Update on Strand Road Cycle Route

5th Nov 2020

Comhairle Cathrach
Bhaile Átha Cliath
Dublin City Council

STRAND ROAD TRIAL RAPID DEPLOYMENT CYCLE ROUTE – AN ALTERNATIVE PROPOSAL

STC Proposal

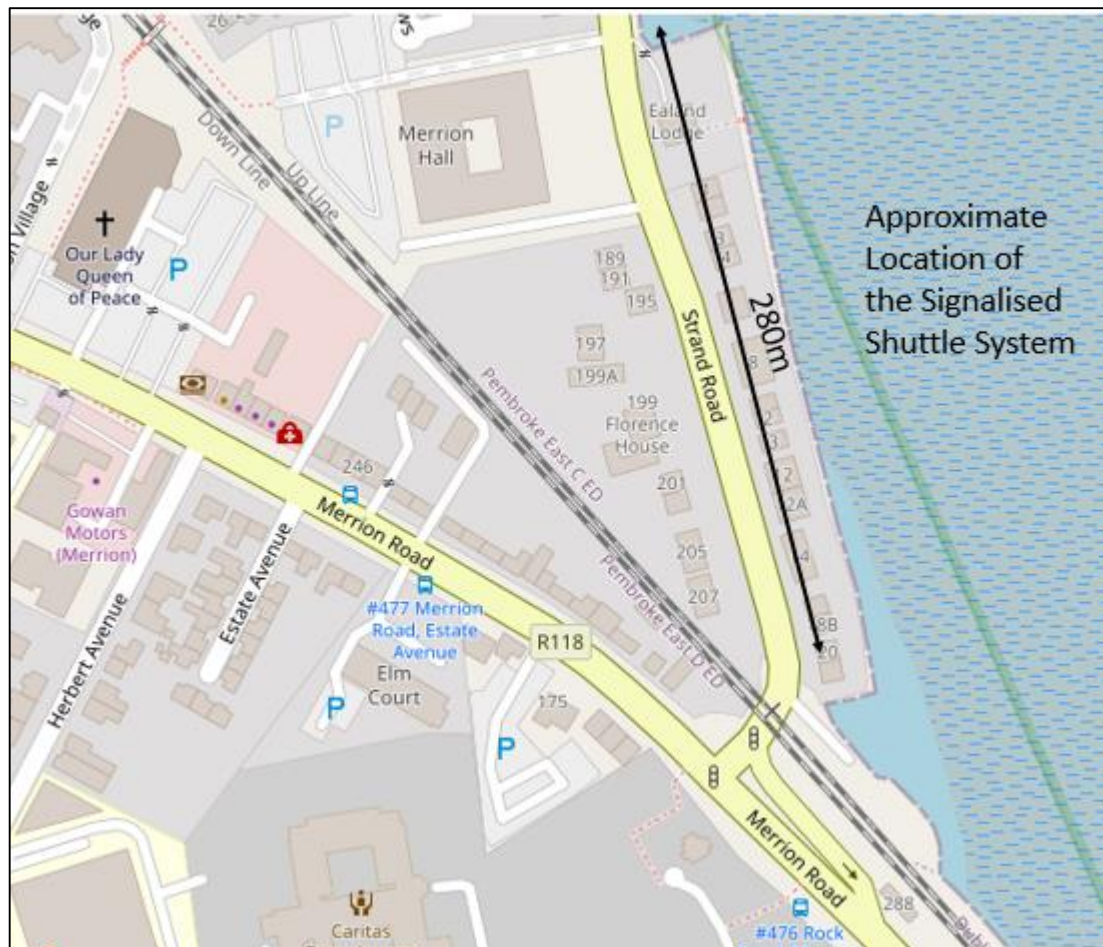
- A rapid deployment cycle route Alternative proposal
- Original proposal was to use the existing seaside footpath as a cycletrack
- Version 2 proposed keeping a 2m footpath on the seaside and extending the footpath to create a cycle track
- Version 2 proposes shuttle running at Merrion Gates.
- 2 way cycletrack would be at the same level as the footpath separated by orcas
- Cycletrack width varies from 2m – 4m for a 2 way cycletrack
- 6m carriageway proposed
- Cyclists to merge with traffic at bus stops

STC Proposal – Merrion Gates section

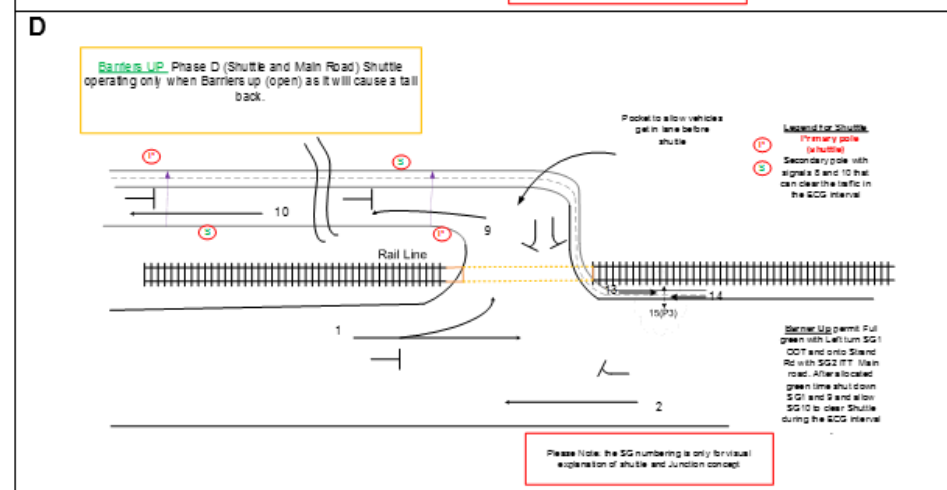
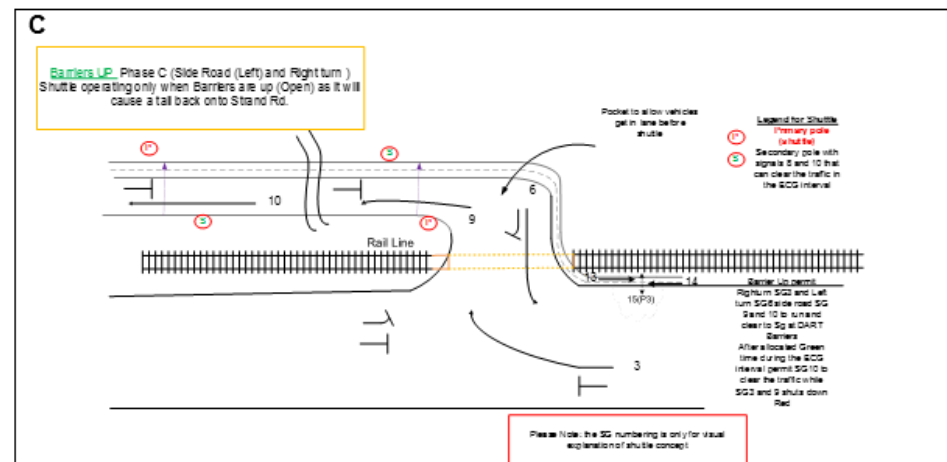
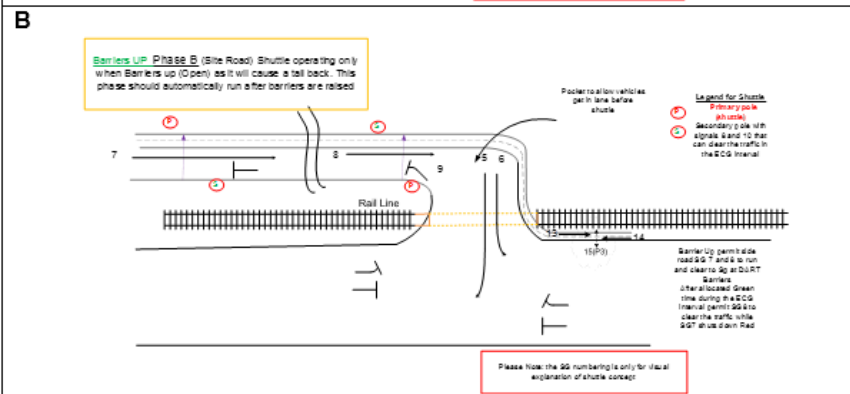
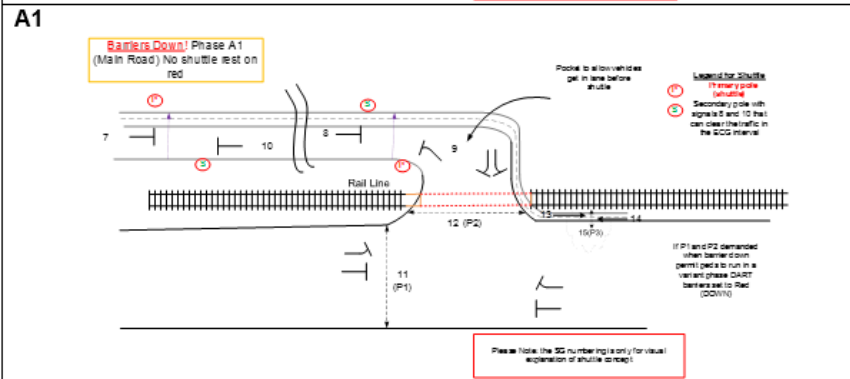
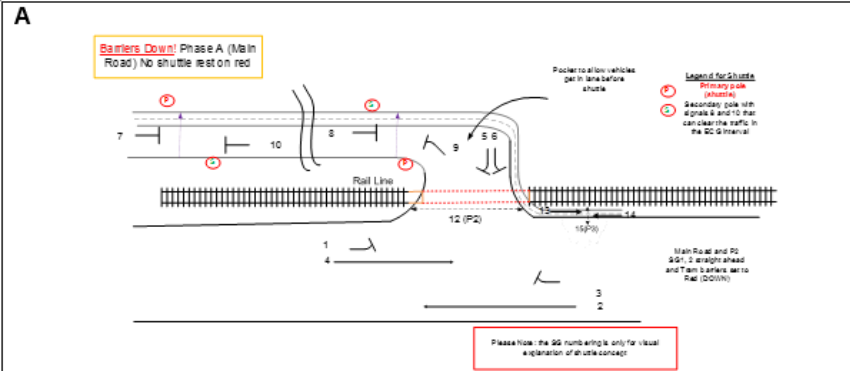
- Merrion gates closures add a complexity to the operation of a shuttle

Length = 280 m clearance time is 35 seconds.

The capacity of a single lane approach to a signalised junction is given simply by the following relationship:

For example, if the shuttle operates at 120 seconds Cycle Length with a saturation flow of 1800 veh/hour and effective green time of 26 seconds then the capacity in each direction is simply 390 veh/hour

Cumulative No. of Vehicles Queuing on Strand Rd Southbound

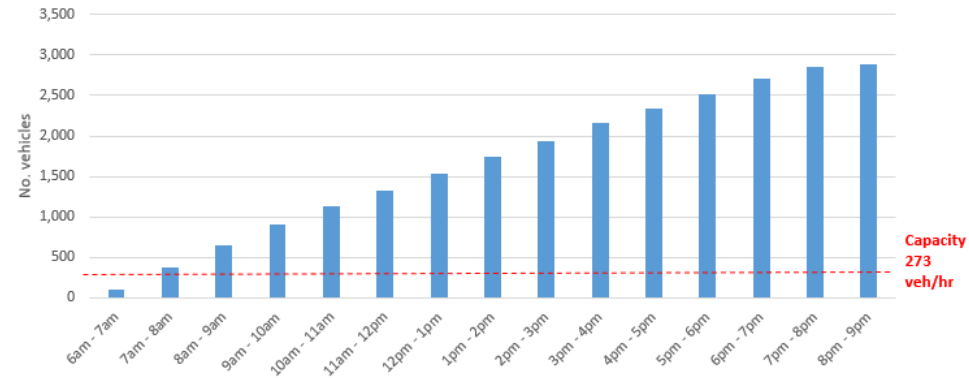
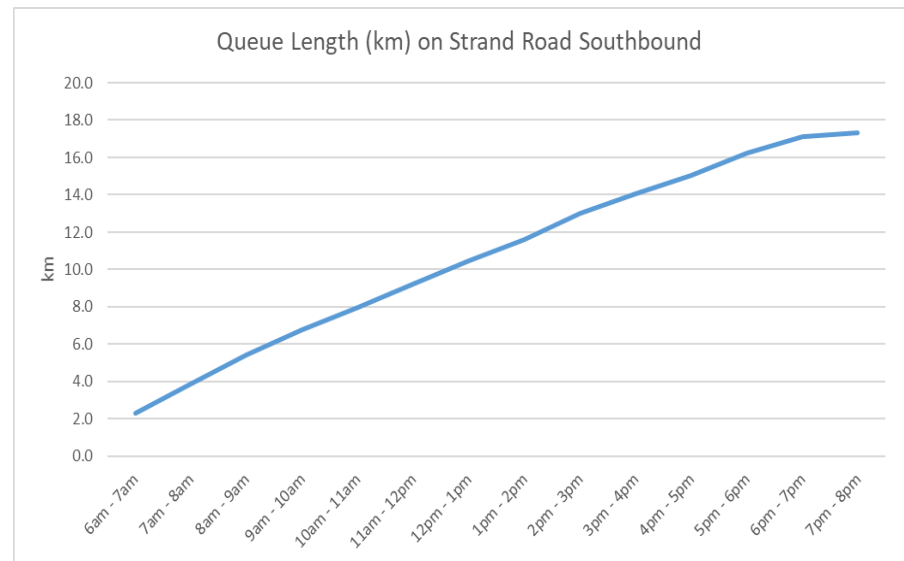
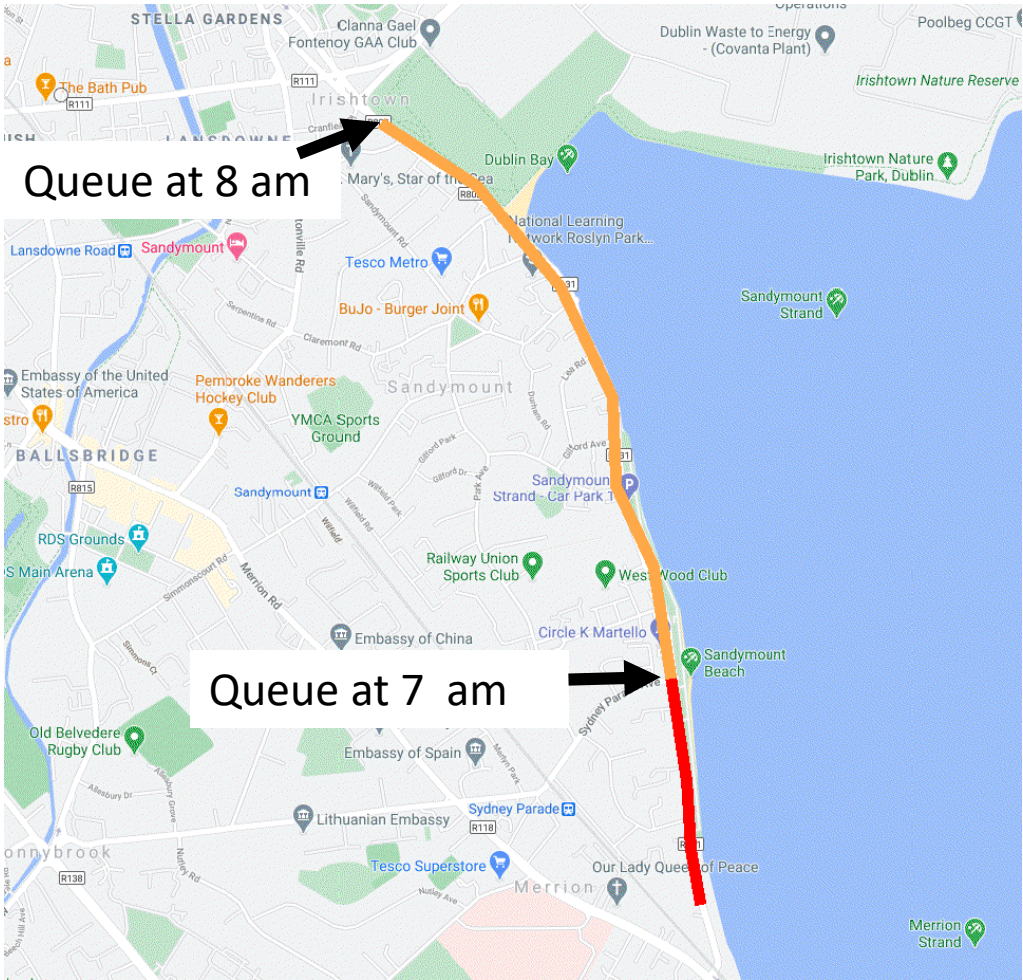
- Cumulative unsatisfied travel demand to cumulative travel demand is approximately 34% in each hour for northbound traffic rising to 43% for southbound traffic.
- The number of vehicles unable to get through the shuttle quickly builds up
- The queue length on Strand Rd by 9am will exceed the length of Strand Rd itself
- There will be a queue of vehicles on Strand Rd all day long
- A vehicle joining the back of the queue at 1pm would not clear the shuttle till almost 6pm
- This will result in a large amount of vehicles diverting through Sandymount in both directions
- The result of this measure is extremely severe

Existing kerb too low
for footpath
extension

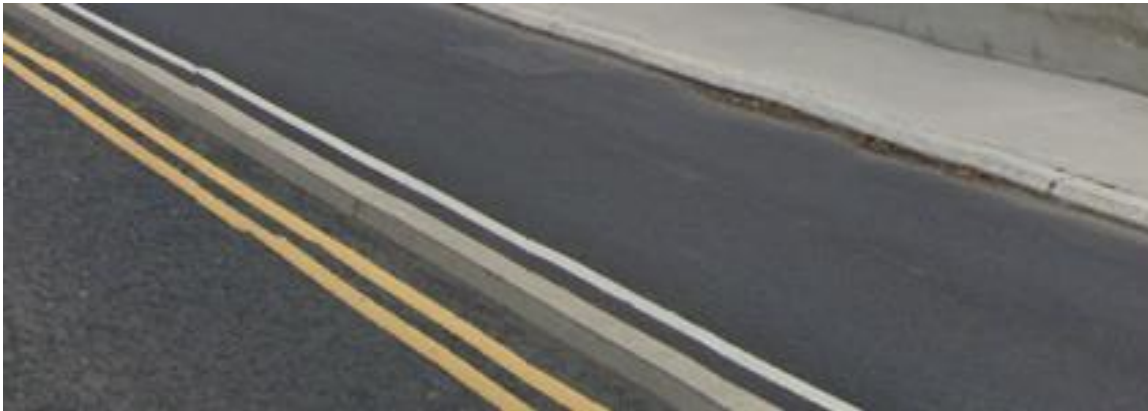
- The existing kerb lines are too low to provide a footpath extension (min 100mm kerb required) and would require to be raised.

STC Proposal in this section:

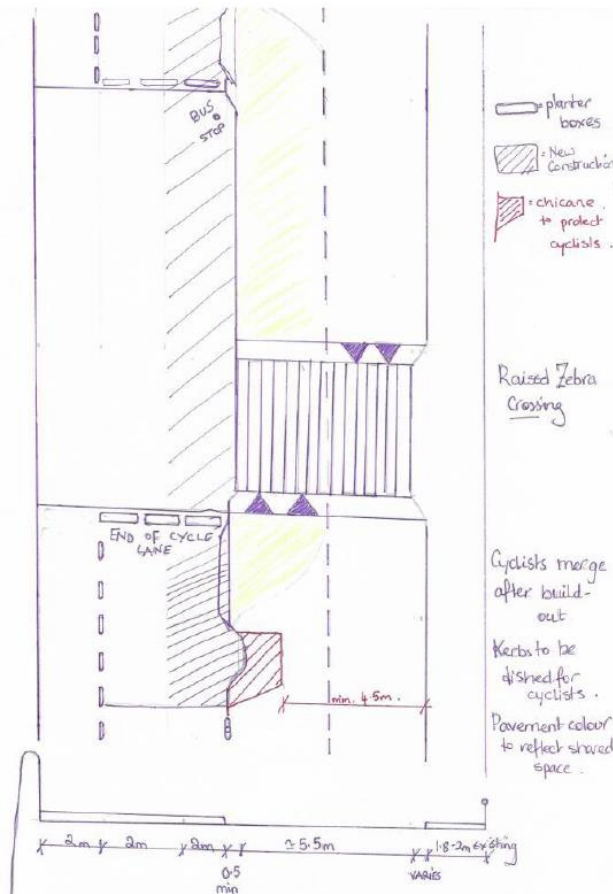
- 2m Footpath
- 6m Carriageway
- 2.6m – 3m cycletrack
- All Parking removed

However there is not consistent 11.3 metres along all sections and even where there is enough space -- extensive civil works are required to make it usable.

- 2m Footpath
- 6.3m Carriageway
- 3m cycletrack
- All Parking removed

STC Proposal – mini roundabouts

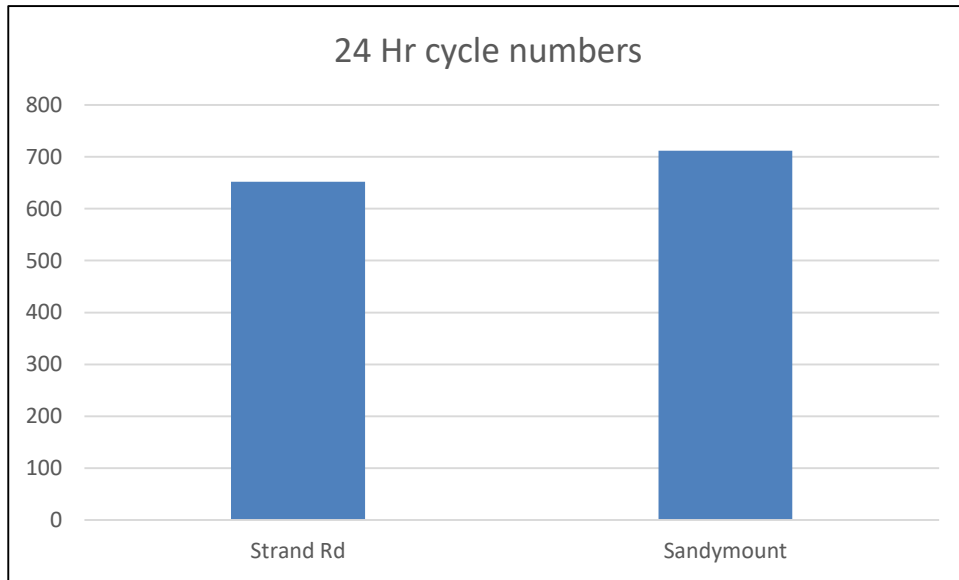
- Proposal didn't include details at the roundabouts
- Proposal for rest of the scheme applied in these locations for assessment
- Extreme difficulties in fitting the realigned reduced roadway and cycle facilities at these junctions
- Roundabouts would need to be removed
- A junction, potentially signalised, or a shuttle system would be required at each location
